R.E. Ginna Nuclear Power Plant
Renewed Facility Operating License No. DPR-18
NRC Docket Nos. 50-244 and 72-67

Subject: License Amendment Request for Approval of Changes to Emergency Plan Staffing Requirements

Subject: License Amendment Request for Approval of Changes to Emergency Plan Staffing Requirements

Figure 2.7—1 Inter-Relationships of Ginna Station Emergency Response Organizations

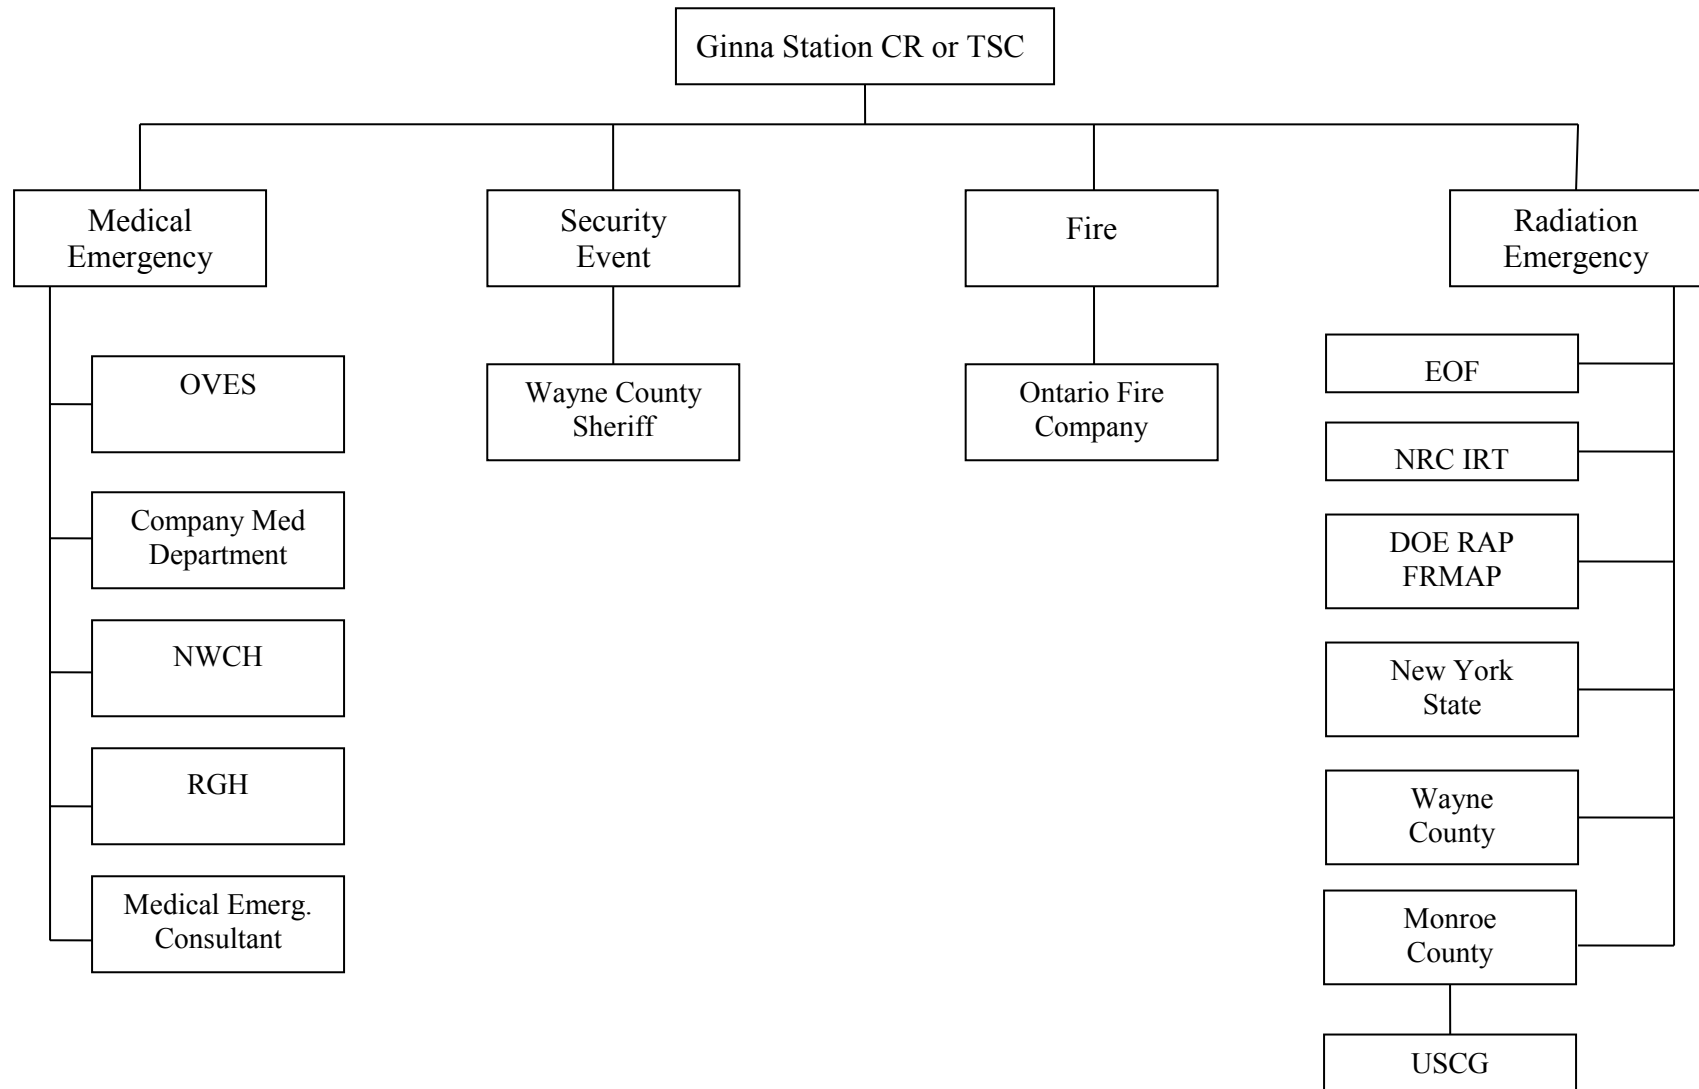
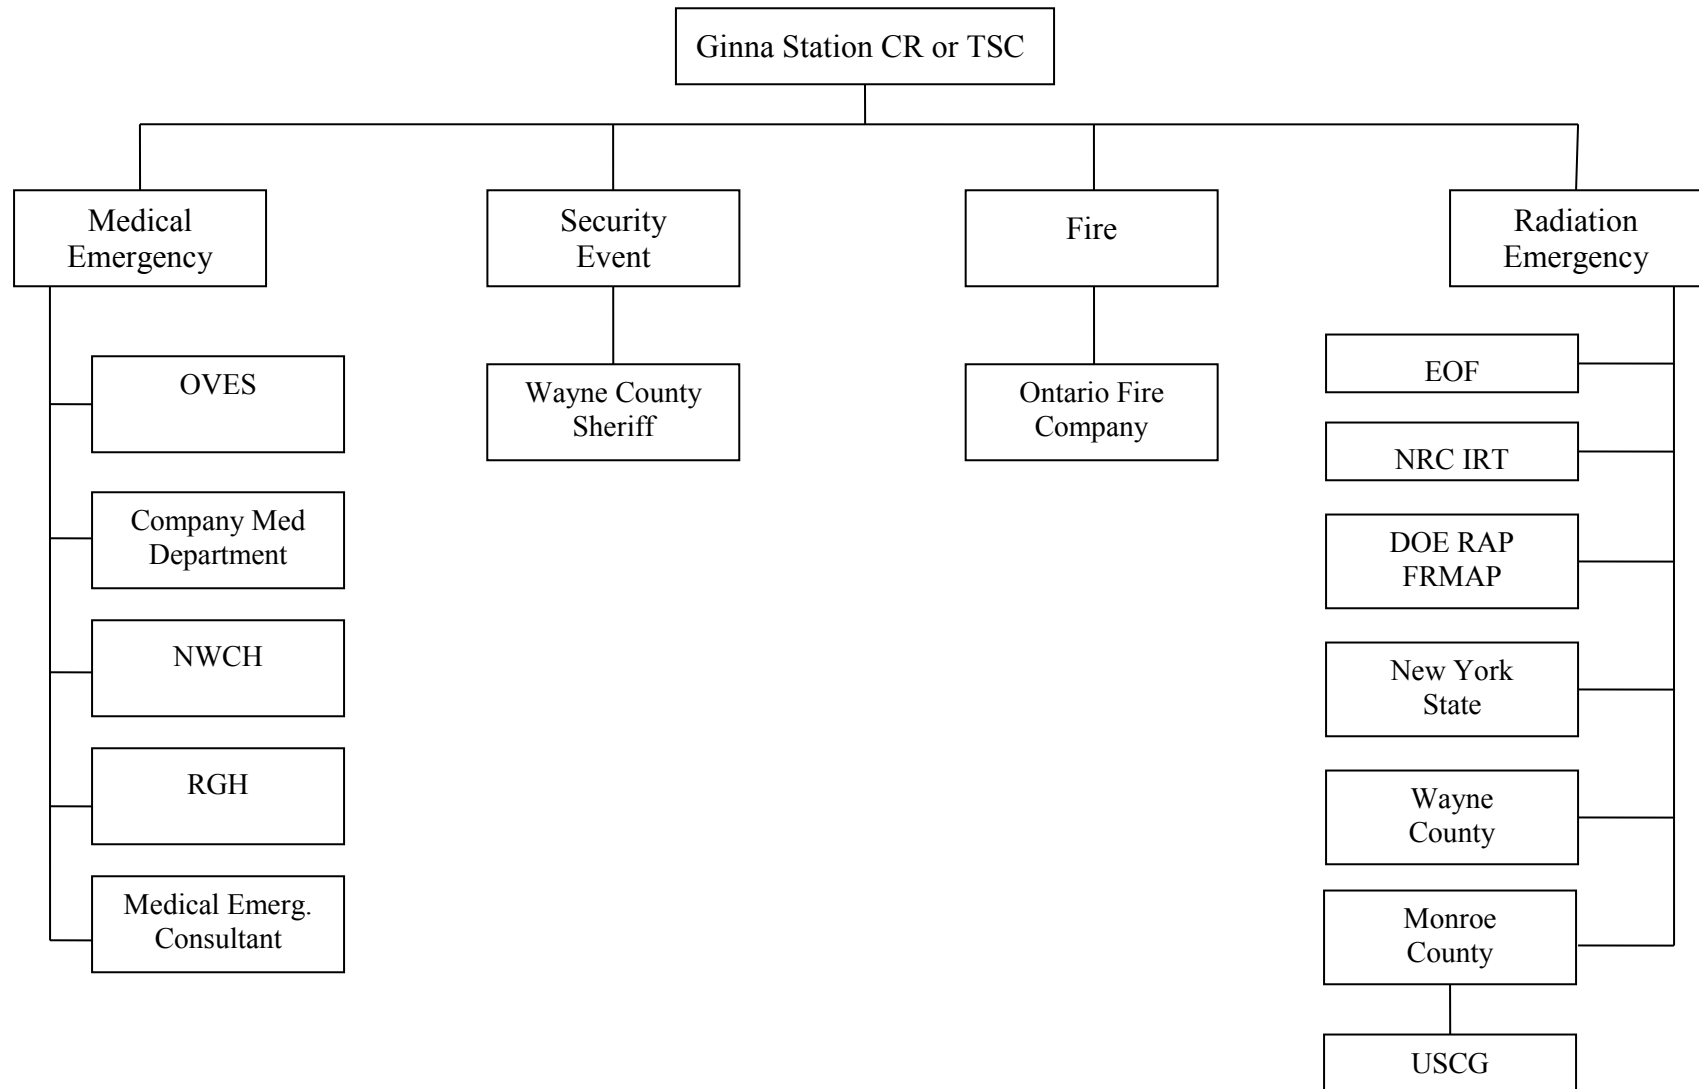
~~Figures 2.1 through 2.7 show the reporting chains and interfaces of the ERO.~~

Figure 2.1 Inter-Relationships of Ginna Station Emergency Response Organizations
